RS-10-102

LaSalle County Station, Units 1 and 2
Facility Operating License Nos. NPF-11 and NPF-18
NRC Docket Nos. 50-373 and 50-374

Subject: Additional Information Supporting License Amendment Request Regarding the Use of Neutron Absorbing Inserts in Unit 2 Spent Fuel Pool Storage Racks

ATTACHMENT 1
Response to Request for Additional Information

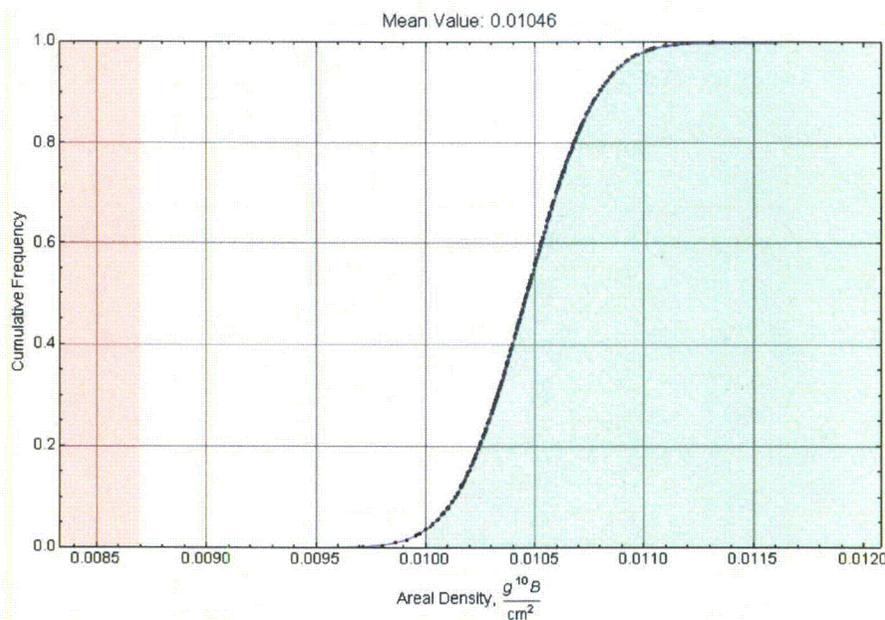
Text from Attachment 1, Section 3.3.2, "Areal Density of Boron," notes that lower limit for the areal density of boron (B) in the Rio Tinto Alcan composite is 0.0087 g Boron-10 per centimeter squared ($^{10}\text{B}/\text{cm}^2$). What is the uncertainty associated with the measurements used to confirm that the "manufacturing insert quality assurance testing lower limit for areal density" is met? Describe how the areal density assumed in the analysis accounts for the measurement uncertainty.

The uncertainty associated with the neutron attenuation testing varies between 0.0003 and 0.0009 $\text{g } ^{10}\text{B}/\text{cm}^2$. This measurement uncertainty is taken into account, at a 95% confidence level, when determining the acceptability of a given coupon test result. Individual tested coupons must exceed the 0.0087 $\text{g } ^{10}\text{B}/\text{cm}^2$ limit with this uncertainty subtracted from the measured value. Additionally, an analysis is performed on the coupon population's areal density to ensure that the 95/95 limit of the production batch exceeds the minimum specified areal density value of 0.0087 $\text{g } ^{10}\text{B}/\text{cm}^2$. Production batches encompass all inserts made from the same stock of raw material. The following plot shows the LaSalle County Station (LSCS) insert test coupons measured to date imposed upon a cumulative normal distribution function having the same mean (0.01046 $\text{g } ^{10}\text{B}/\text{cm}^2$) and standard deviation (0.00026 $\text{g } ^{10}\text{B}/\text{cm}^2$) as the population of test coupons. The red region to the left represents the region of the plot that falls below the minimum certified value. The population reflected in the plot consists of 394 samples and has a minimum value of 0.0097 $\text{g } ^{10}\text{B}/\text{cm}^2$ and an uncertainty on the mean of 0.000013 $\text{g } ^{10}\text{B}/\text{cm}^2$. With 95% confidence, 95% of the population of measurements falls within the green area of the plot with a minimum 95/95 value of 0.0100 $\text{g } ^{10}\text{B}/\text{cm}^2$. It can be seen that the population is well in excess of the minimum certified value for the LSCS inserts. This methodology is to be applied to all inserts produced for LSCS to insure appropriate margin to criticality.
